Baseline for Figure 33-14 update to Type 3 and Type 4, v232

33.2.4.4 Variables

Figure 33-14a

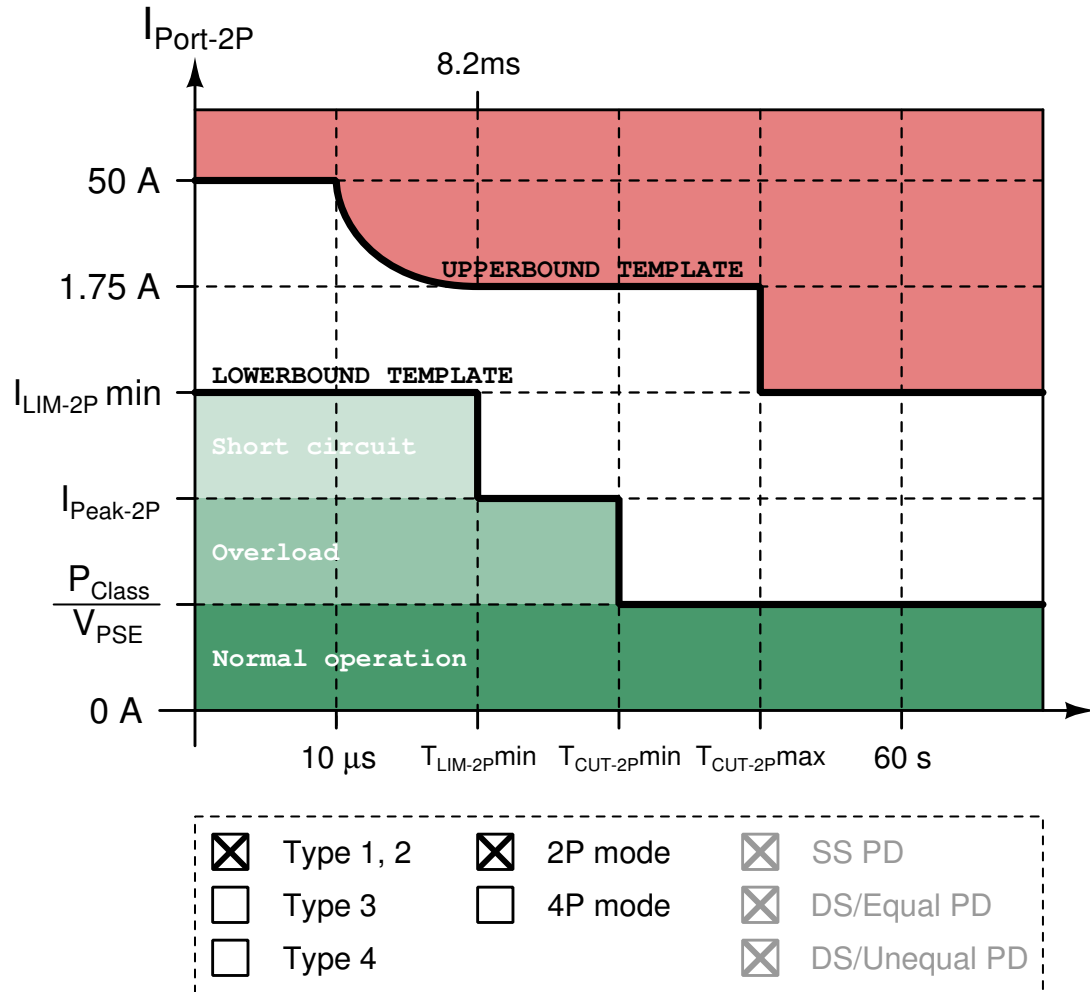
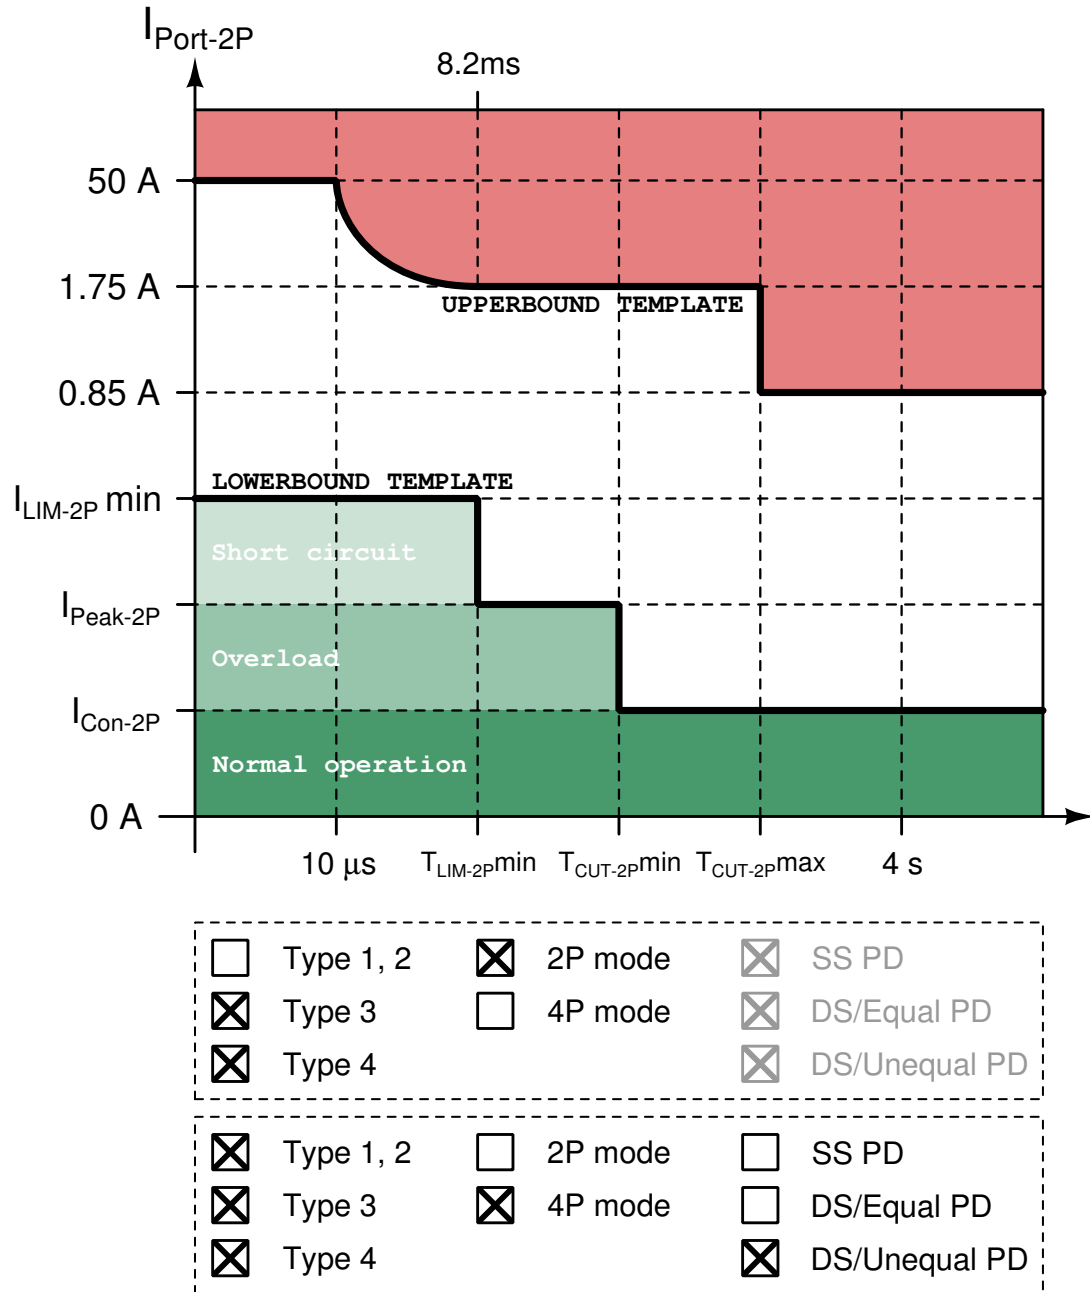
- Equation 33-6, Equation 33-7 and Figure 33-14 apply to Type 1 and Type 2 PSEs.
- Equation 33-6a, Equation 33-7a and Figure 33-14a apply to Type 3 and Type 4 PSEs that operate in 2-pair mode, as well as to Type 3 and Type 4 PSEs operating in 4-pair mode, connected to a Dual-signature PD that advertised a different class signature on each pairset.

**Info (not part of baseline!)**

The fixed current limit of 0.85A in the upperbound template is introduced to allow a PSE to set an I_{CUT} limit that is Type-fixed and does not need to change with Class. We are limited by LPS (Limited Power Source, IEC60950) requirements (source $\leq 100\text{W}$) therefore the maximum continuous current per pairset allowed is:

$$\frac{100\text{W}}{57\text{V}}/2 = 877\text{mA}$$

By choosing 0.85A the maximum allowed sustained power for Type 3 is $0.85\text{A} \times 2 \times 57\text{V} = 96.9\text{W}$.

$$I_{\text{PSEUT-2P}}(t) = \left\{ \begin{array}{ll} 50 & \text{for } (0 \leq t < 10.0 \times 10^{-6}) \\ \sqrt{\frac{K}{t}} & \text{for } (10.0 \times 10^{-6} \leq t < 8.20 \times 10^{-3}) \\ 1.75 & \text{for } (8.20 \times 10^{-3} \leq t < T_{\text{CUT-2P max}}) \\ 0.85 & \text{for } (T_{\text{CUT-2P max}} \leq t) \end{array} \right\}_A \quad (33-6a)$$

$$I_{\text{PSELT-2P}}(t) = \left\{ \begin{array}{ll} I_{\text{LIM-2P min}} & \text{for } (0 \leq t < T_{\text{LIM-2P min}}) \\ I_{\text{Peak-2P}} & \text{for } (T_{\text{LIM-2P min}} \leq t < T_{\text{CUT-2P min}}) \\ I_{\text{Con-2P}} & \text{for } (T_{\text{CUT-2P min}} \leq t) \end{array} \right\}_A \quad (33-7a)$$

Figure 33-14c

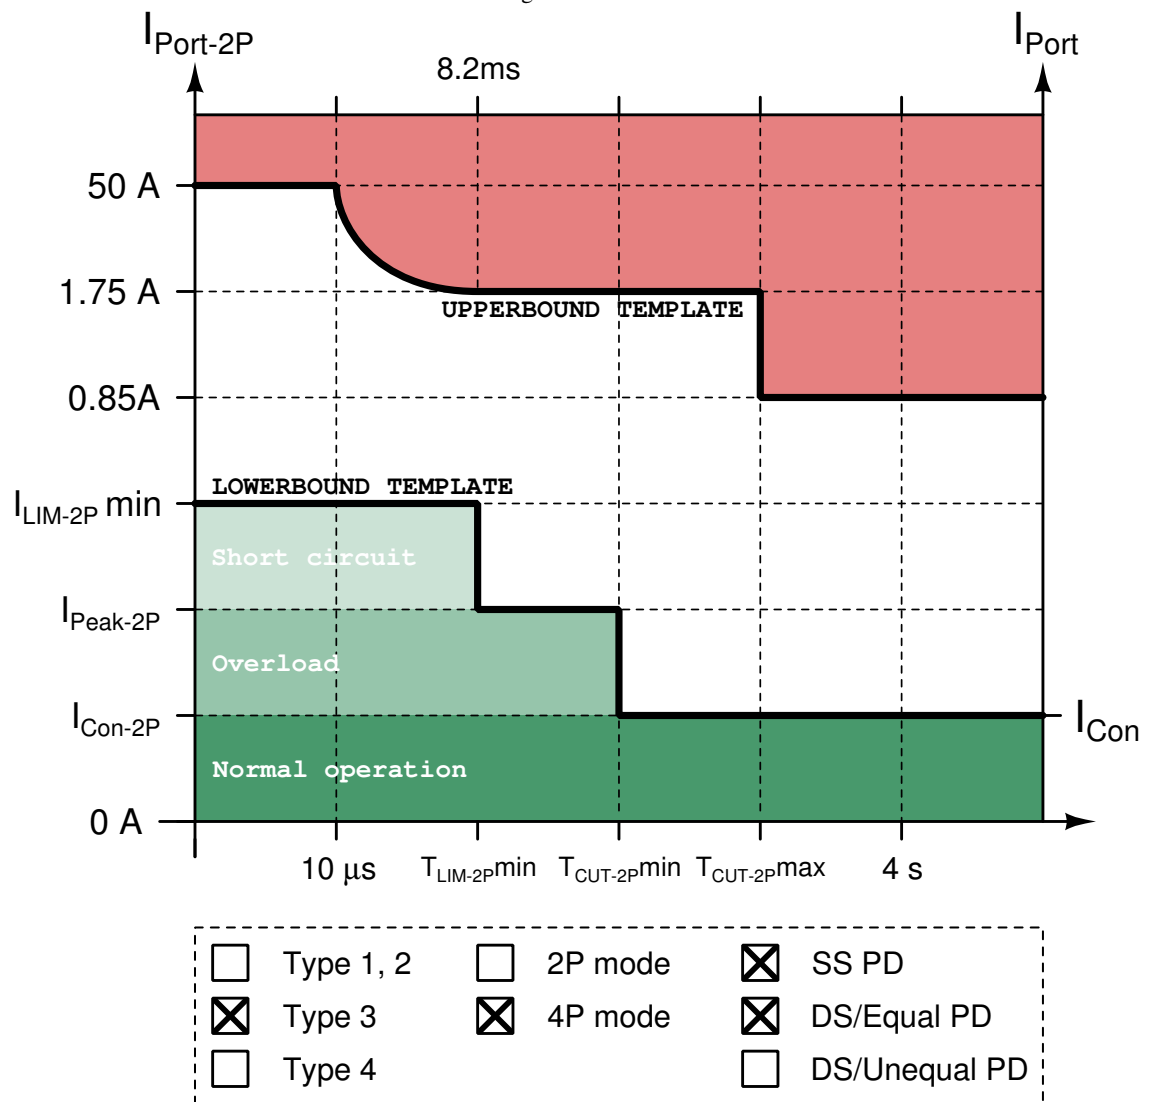
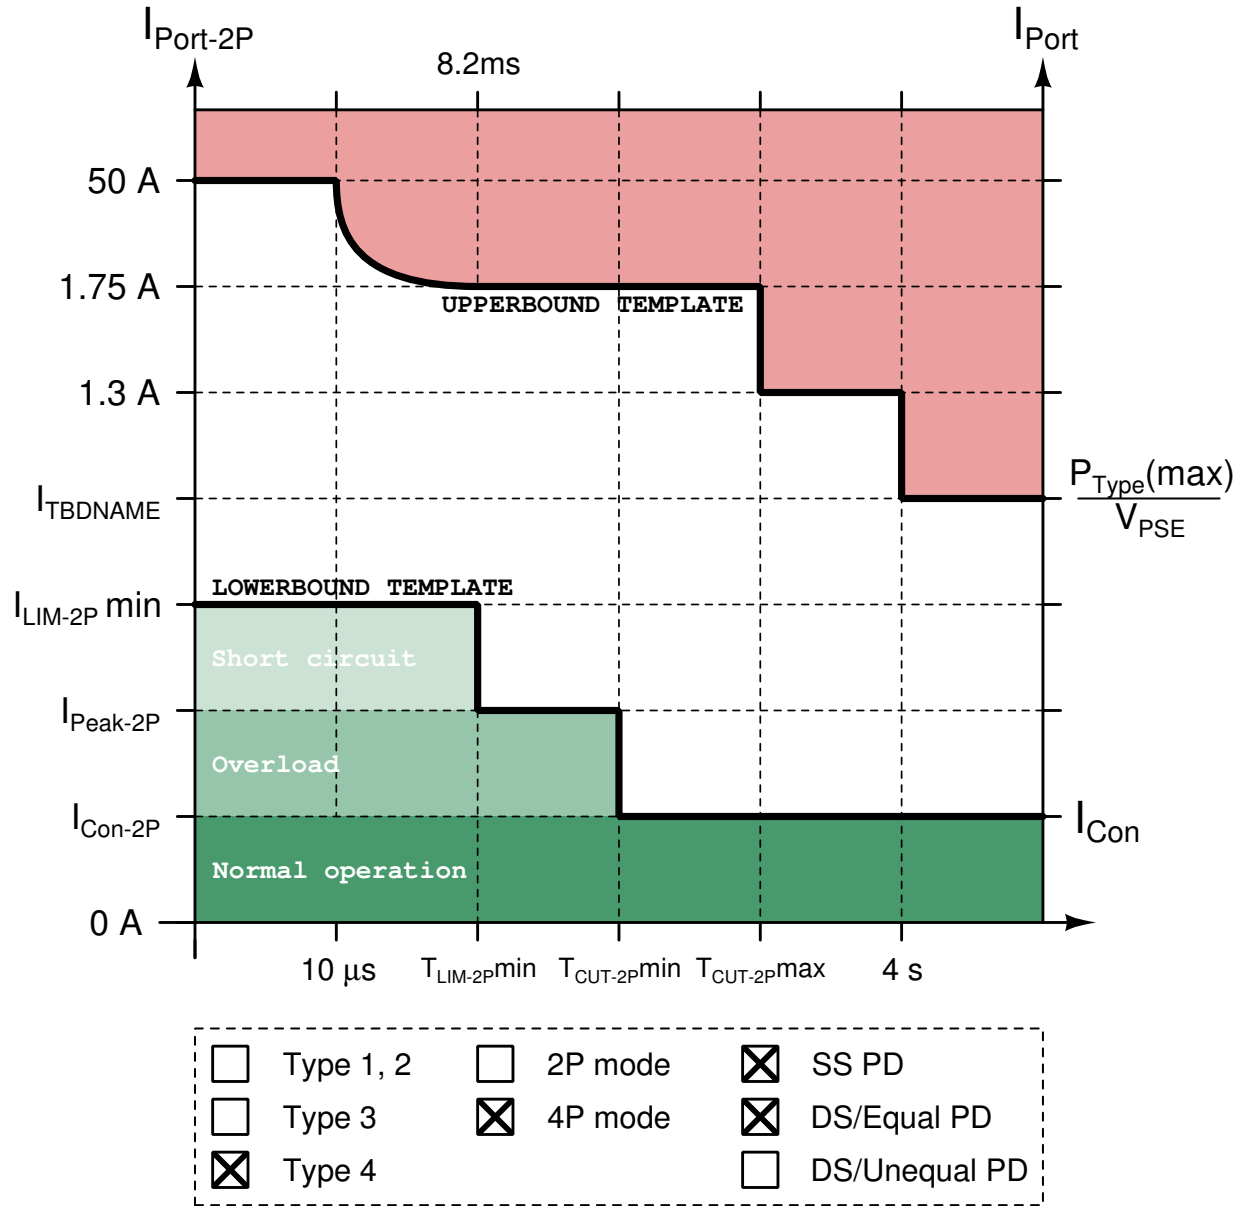
- Equation 33-6b, Equation 33-7b and Figure 33-14b apply to Type 3 PSEs operating in 4-pair mode, connected to a Single-signature PD, or connected to a Dual-signature PD that advertised the same class signature on each pairset.
- Equation 33-6c, Equation 33-7c and Figure 33-14c apply to Type 4 PSEs operating in 4-pair mode, connected to a Single-signature PD, or connected to a Dual-signature PD that advertised the same class signature on each pairset.

$$I_{\text{PSEUT-2P}}(t) = \left\{ \begin{array}{ll} 50 & \text{for } (0 \leq t < 10.0 \times 10^{-6}) \\ \sqrt{\frac{K}{t}} & \text{for } (10.0 \times 10^{-6} \leq t < 8.20 \times 10^{-3}) \\ 1.75 & \text{for } (8.20 \times 10^{-3} \leq t < T_{\text{CUT-2P max}}) \\ I_{\text{TBDNAME}} & \text{for } (T_{\text{CUT-2P max}} \leq t) \end{array} \right\}_A \quad (33-6c)$$

$$I_{\text{PSELT-2P}}(t) = \left\{ \begin{array}{ll} I_{\text{LIM-2P min}} & \text{for } (0 \leq t < T_{\text{LIM-2P min}}) \\ I_{\text{Peak-2P}} & \text{for } (T_{\text{LIM-2P min}} \leq t < T_{\text{CUT-2P min}}) \\ I_{\text{Con-2P}} & \text{for } (T_{\text{CUT-2P min}} \leq t) \end{array} \right\}_A \quad (33-7c)$$

$$I_{\text{TBDNAME}} = \min \left(\frac{P_{\text{Type max}}}{V_{\text{PSE}}} - I_{\text{Port-2P-other}}, 1.3 \right) \quad (33-7c)$$
